Memorandum to the City of Markham Committee of Adjustment

File: A/11/18
Address: 5 Lakevista Avenue, Markham
Applicant: Shen Zhang & Yi Song
Agent: Rubinoff Design Group (Glenn Rubinoff)
Hearing Date: Wednesday March 14, 2018

SECOND FLOOR PLAN

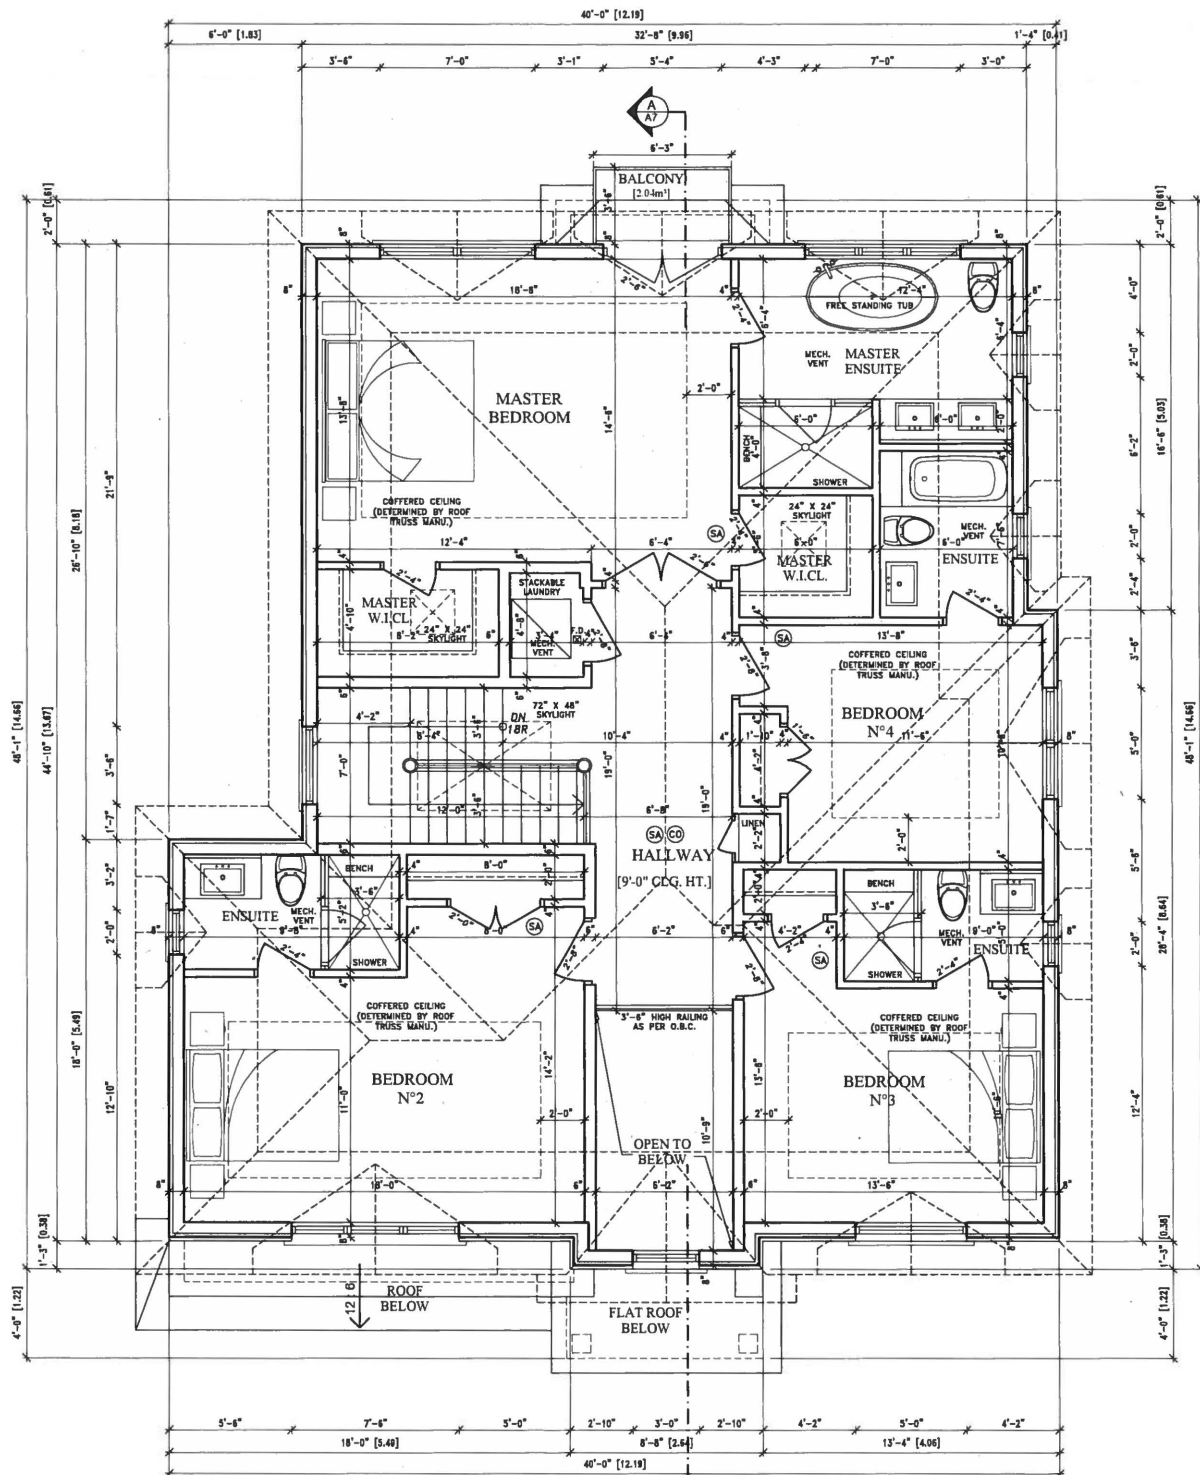
Floor Area Ratio is a measurement of the interior square footage of the dwelling as a percentage of the net lot area. It is not a definitive measurement of the mass of the dwelling, since it does not include "open to below" areas that may exist within the dwelling (e.g. two-storey foyers, atriums and/or stairs). In addition to the area associated with the stairs, there is an open to below area of approximately 6.14 m² (66 ft²) above the foyer.
